Work Order ID 112514

APICAL INDUSTRIES, INC.	ENGINEERING CHANGE NOTICE NO. 03700				SHEET 1 OF 1	
	DWG NO. 647.9100	REV: N/C	PREPARED BY B. PETERS	DATE: 11/15/12	EFFECT ON DWG <input type="checkbox"/> INC. <input checked="" type="checkbox"/> UNINC.	
	DWG TITLE: THRUSERT					
	APPROVED BY: ENGR <i>[Signature]</i>	MFG <i>[Signature]</i>	QC <i>[Signature]</i>	EFF: NEXT ORDER		
TRANSACTION CODES (TC): A-ADD C-CREATE R-REVISE D-DELETE	REASON: ADDED ALTERNATE MATERIAL.				ECR: D-12-007

APICAL INDUSTRIES, INC.	ENGINEERING CHANGE NOTIC NO. 03294				SHEET 1 OF 1	
	DWG NO. 647.9100	REV: N/C	PREPARED BY A. QUAN	DATE: 12/07/11	EFFECT ON DWG <input type="checkbox"/> INC. <input checked="" type="checkbox"/> UNINC.	
	DWG TITLE: THRUSERTS					
APPROVED BY: ENGR <i>[Signature]</i>		MFG <i>[Signature]</i>	<i>[Signature]</i>	EFF: CURRENT ORDER		
TRANSACTION CODES (TC): A-ADD C-CREATE R-REVISE D-DELETE		REASON: REVISED MATERIAL DUE TO AVAILABILITY ISSUES

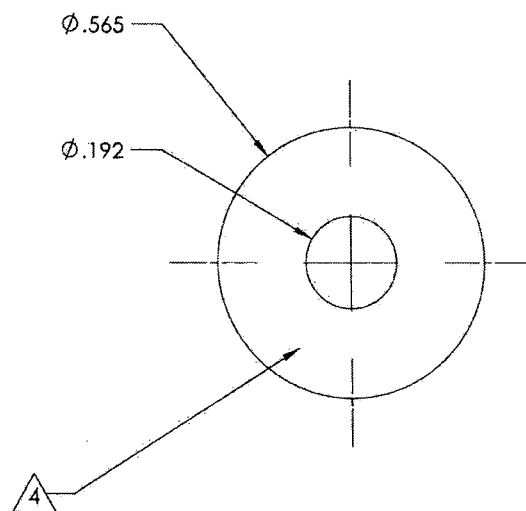
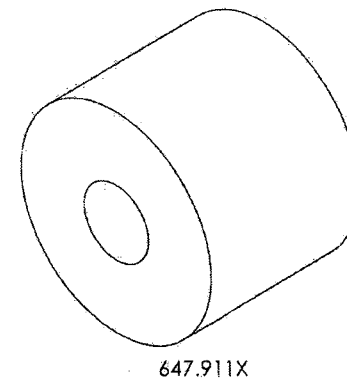
SHEET 1, ZONE A2 IS:

SHEET 1, NOTES IS:

1. PRIMARY MATERIAL: 303 SS IAW AMS 5640
ALTERNATE MATERIAL: AISI 303 SS PER ASTM A582

1. MATERIAL: 303 SS IAW AMS 5640.
2. FINISH: NONE.
3. DEBURR AND BREAK ALL SHARP EDGES.
4. IDENTIFY IAW MPP-120. LASER ETCH P/N AND REVISION 12 PT. CENTURY GOTHIC.
